A303 Amesbury to Berwick Down

TR010025

**8.64 - Comments on any further information received by
the ExA and received to Deadline 9**

Comments on any further information received by the ExA and received to Deadline 9

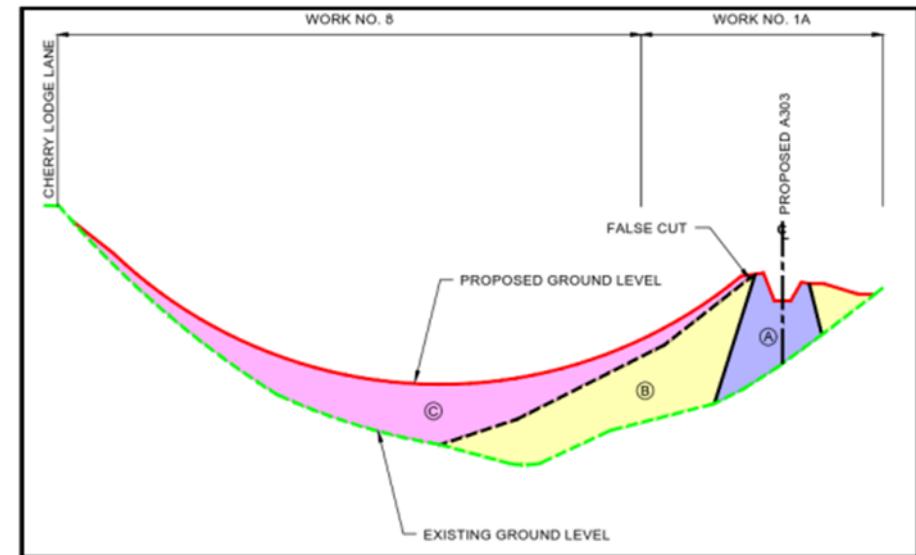
11.1.14**M & R Hosier response to 8.49**

The Applicant informs us that the “cakes” from the Slurry Treatment Works will be wet and not dry material. This is “to be placed by dump trucks, so the only proposed compaction will be by the plant employed to place and spread the fill ie dump trucks and the dozers. It is expected that low ground pressure plant will be employed for this purpose to prevent over-compaction”. This comment raises the concern for landslides, as a result of lack of compaction of material. The Applicant comments that “material deposited will not be subject to structural compaction”. Aberfan disaster in 1953 was as a result of compacted material deposited over an area of highly porous sandstone with underwater streams. To what depth will the “cakes” be spread over Parsonage Down? What measures are being taken to prevent the material slipping from where it meets the natural ground level of Parsonage Down.

The various design features of the structural embankment and the landscaping were explained in response to Written Question WM.2.2 [REP6-033] which included the following schematic cross section where area (A) is the structural embankment and areas (B) and (C) are landscape fill.

All earthworks fill, whether for structural or landscape purposes, will require a level of compaction suitable for their finished slope and loading combination. Fill placed against existing or pre-constructed slopes will be “benched” into the existing slope, i.e. steps will be cut into the existing slope so that the new embankment is founded on flat ground. These measures of compaction and benching will ensure that the new fill will not slip.
